Mahopac Central School District
Mahopac, New York

Reconstruction to
Mahopac Public Library

BID Addendum No. 2
to
Drawings and Project Manual

August 11, 2022

Untitled Map
Logistics Plan

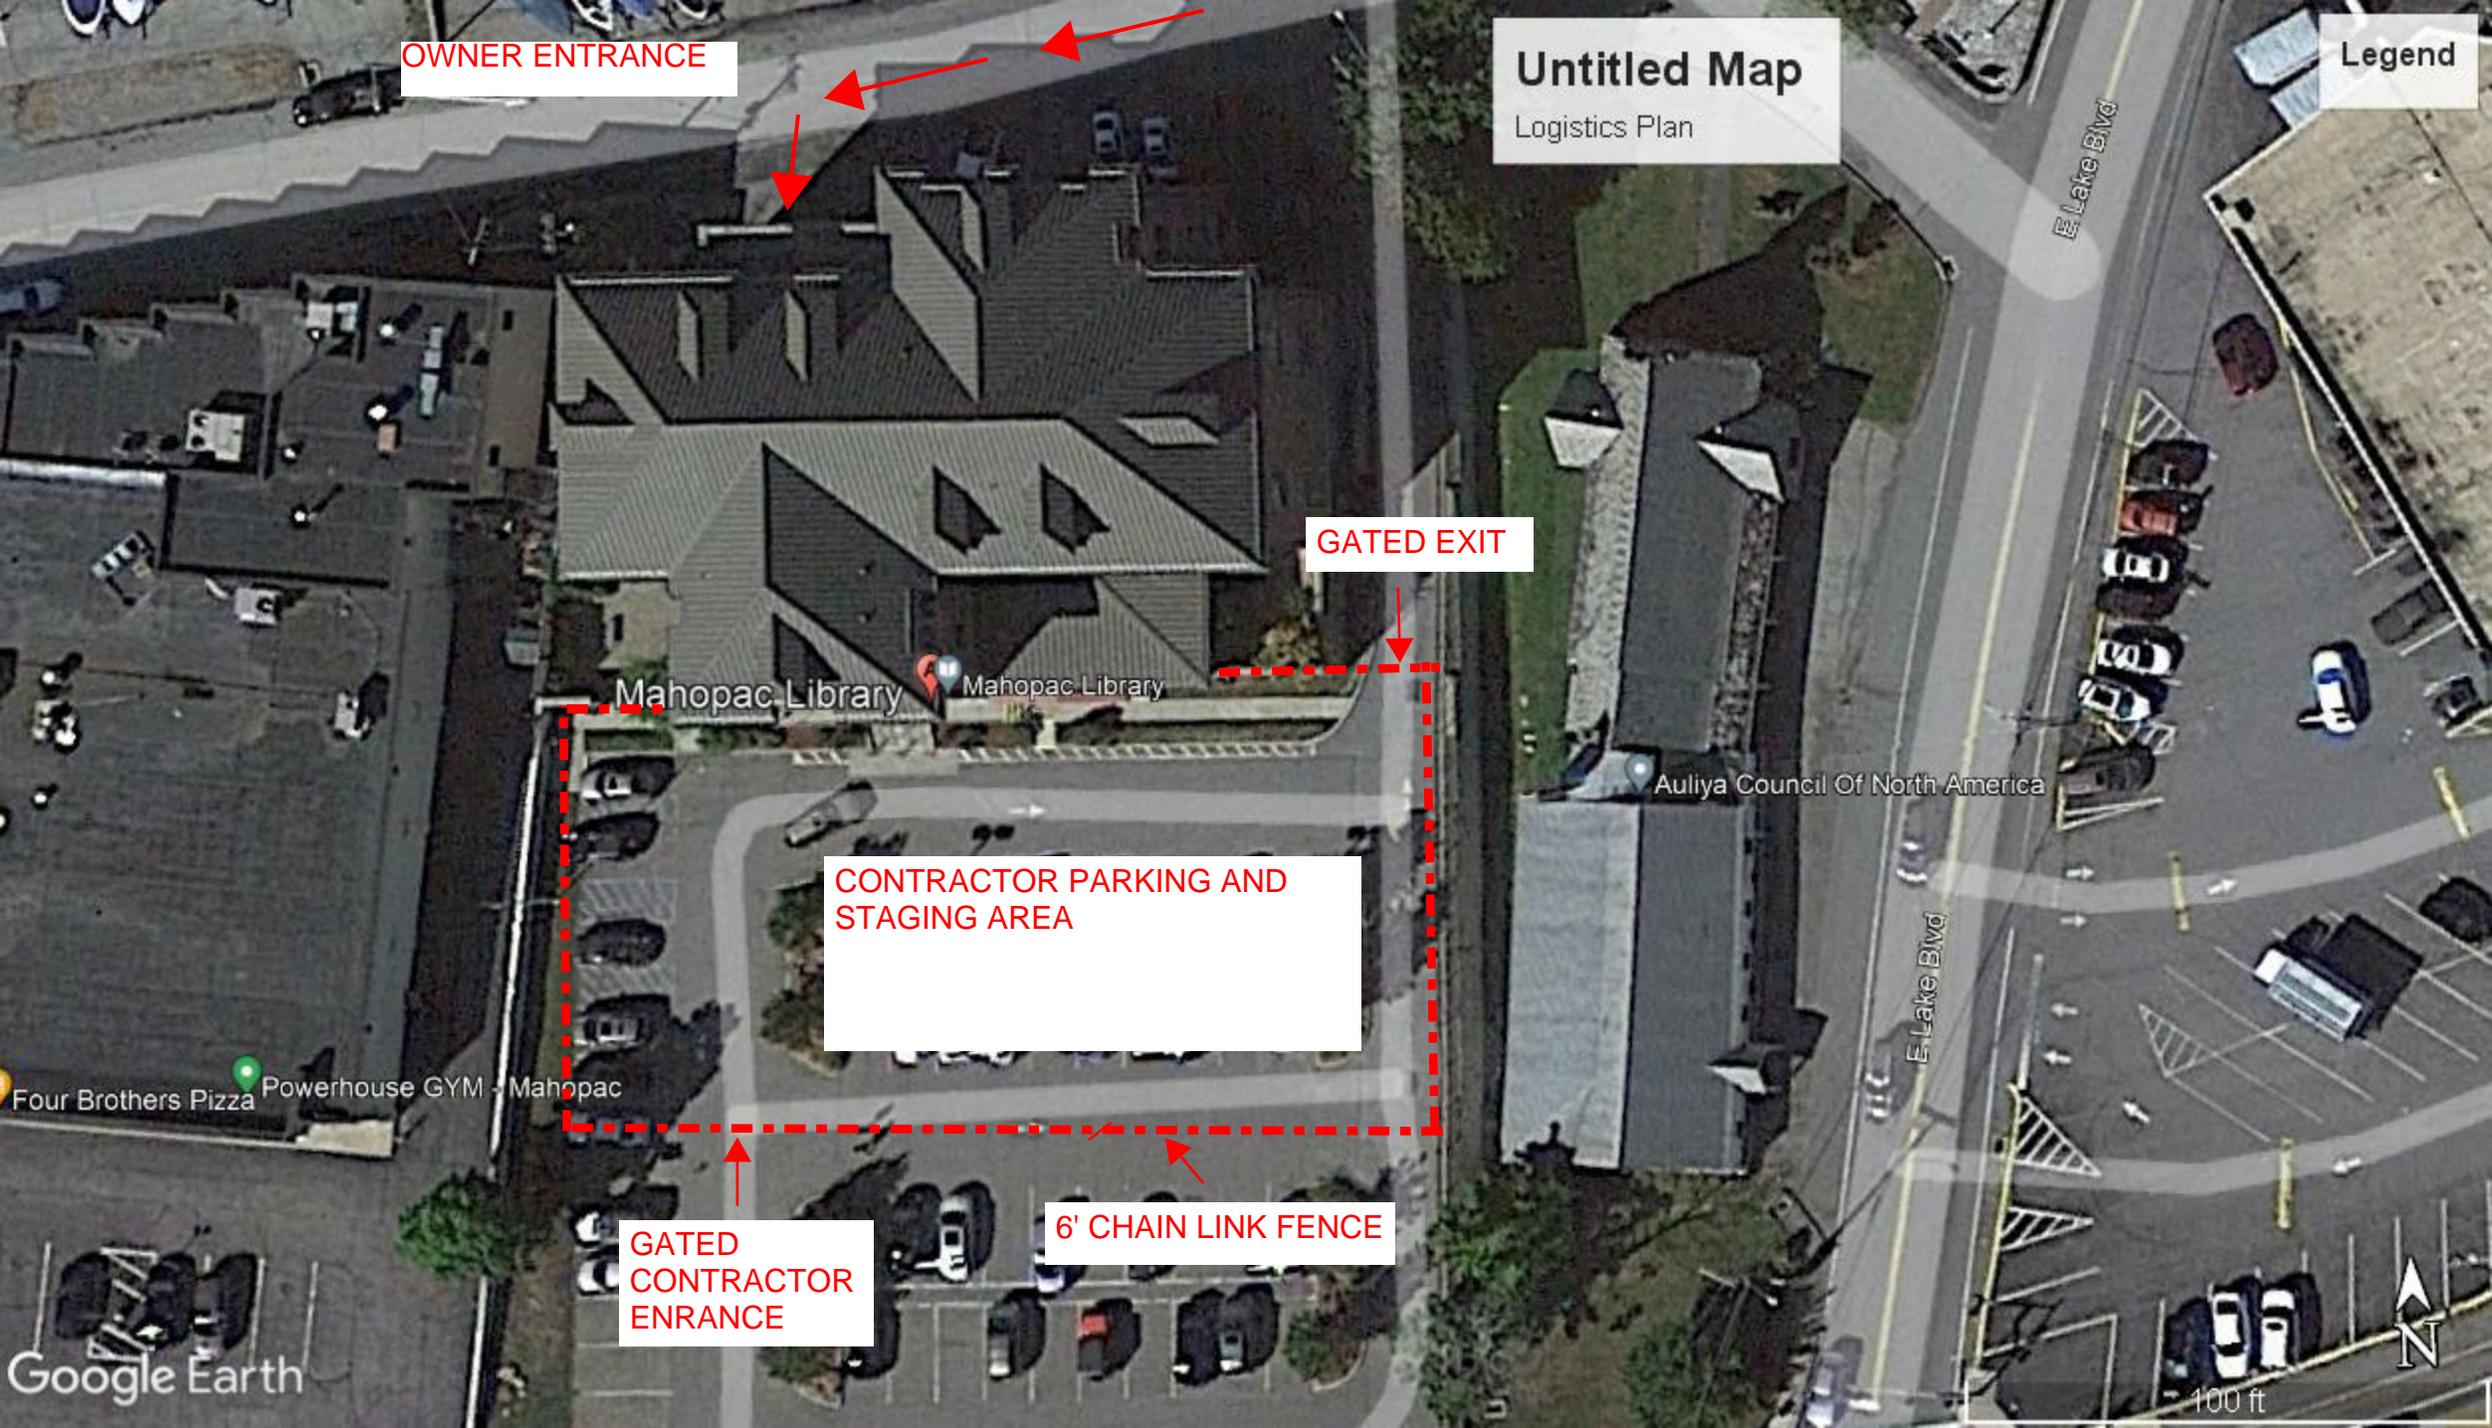
2. ADD Logistics Plan attached to this addendum.

Basement and First Floor Demolition Plans

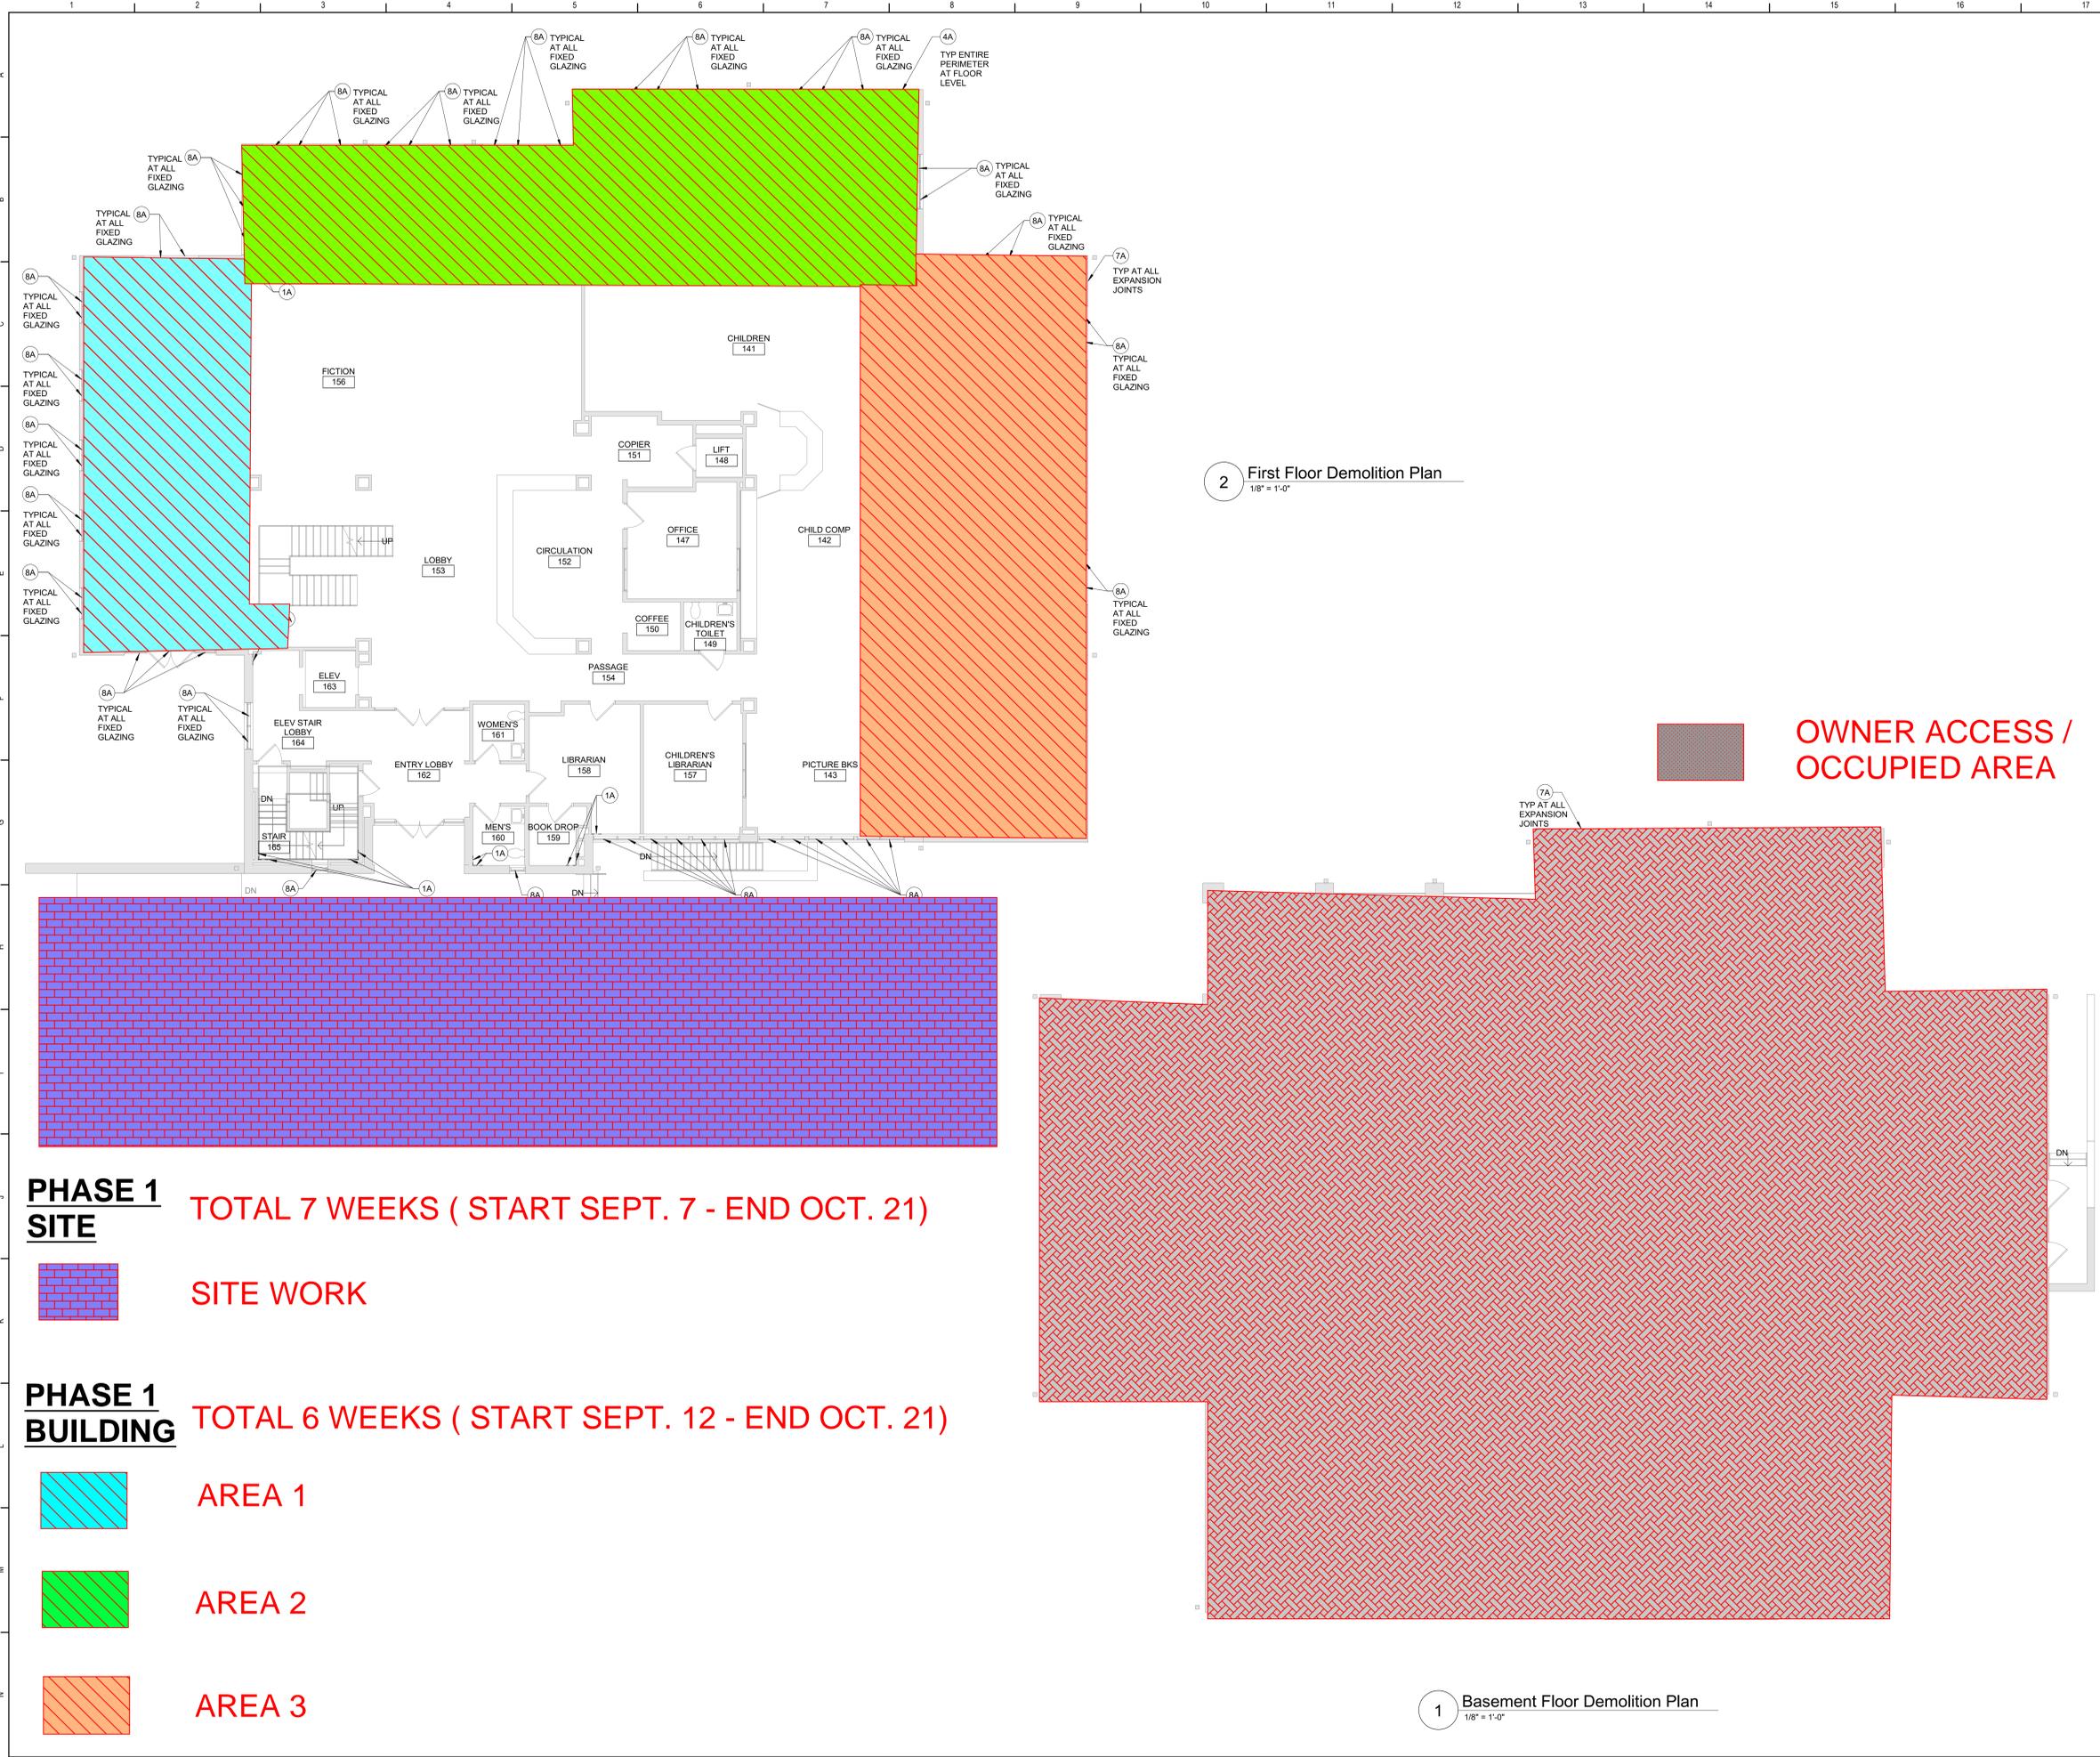
3. ADD First Floor Phasing Plan attached to this addendum.

PHASE 1 SITE TOTAL 7 WEEKS (START SEPT. 7 - END OCT. 21)

PHASE 1 BUILDING TOTAL 6 WEEKS (START SEPT. 12 - END OCT. 21)

Second and Third Floor Demolition Plans

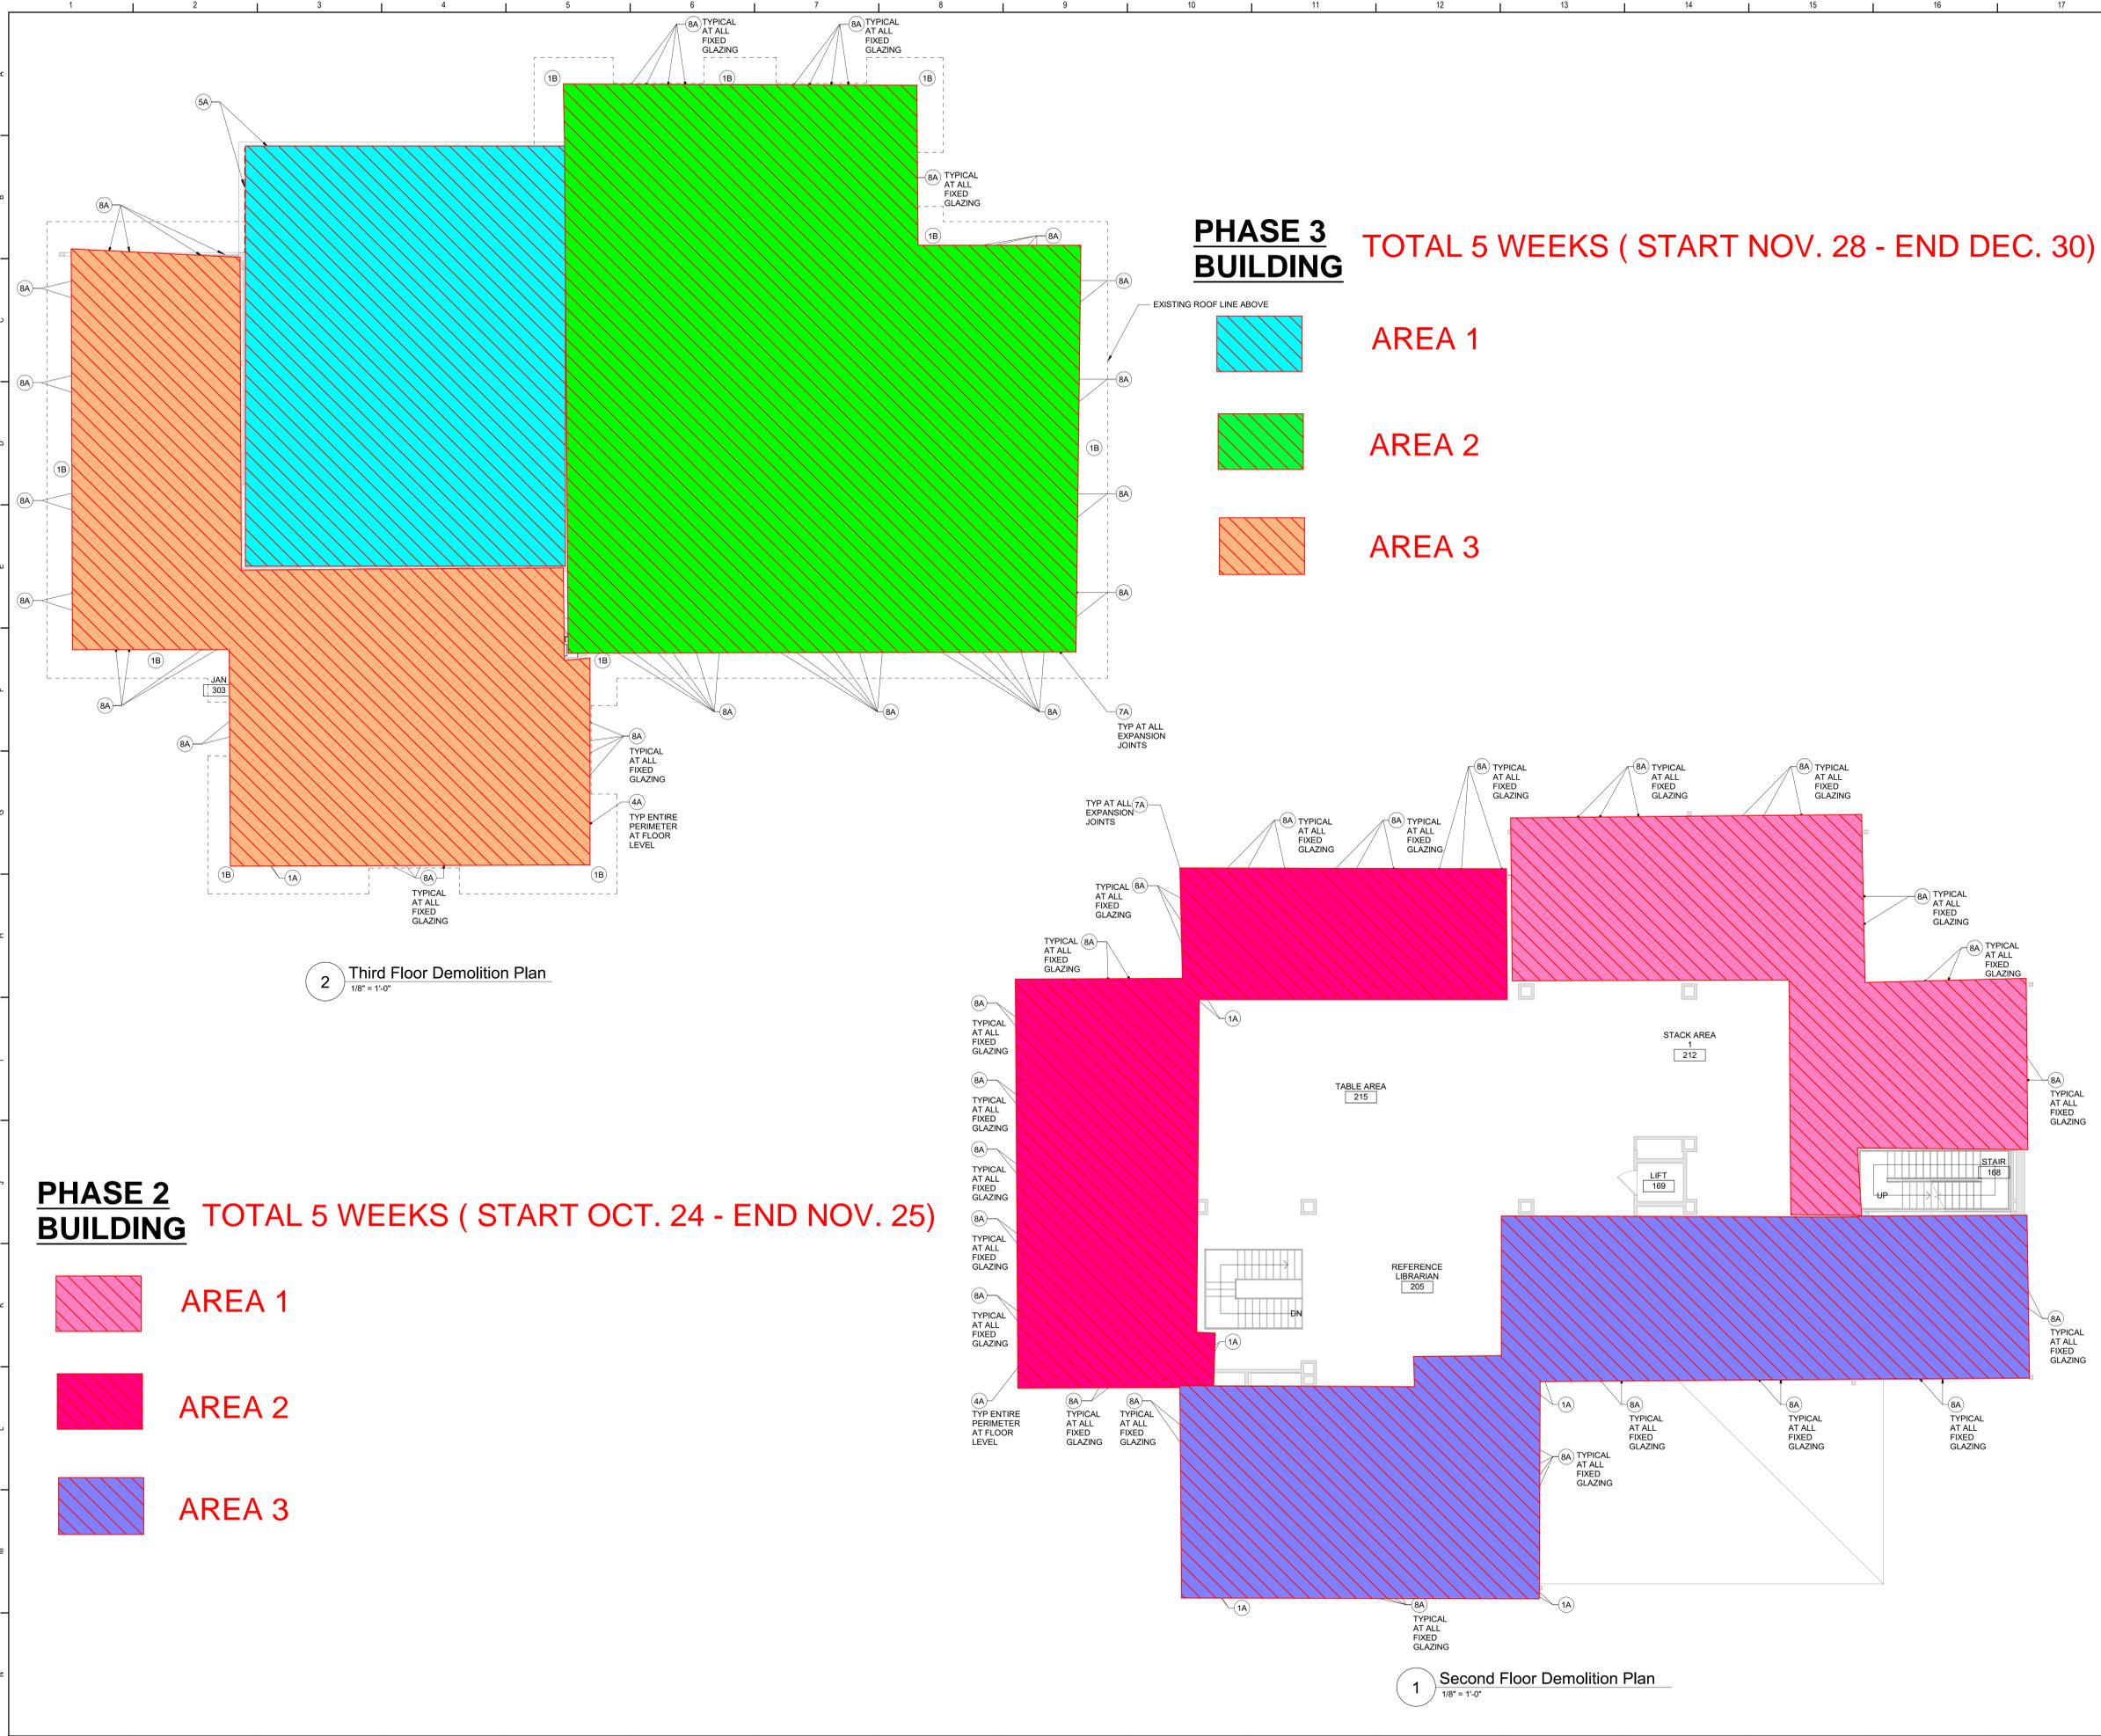
4. ADD Second-Third Floor Phasing Plan attached to this addendum.

PHASE 3 BUILDING

TOTAL 5 WEEKS (START NOV. 28 - END DEC. 30)

PHASE 2 BUILDING

TOTAL 5 WEEKS (START OCT. 24 - END NOV. 25)
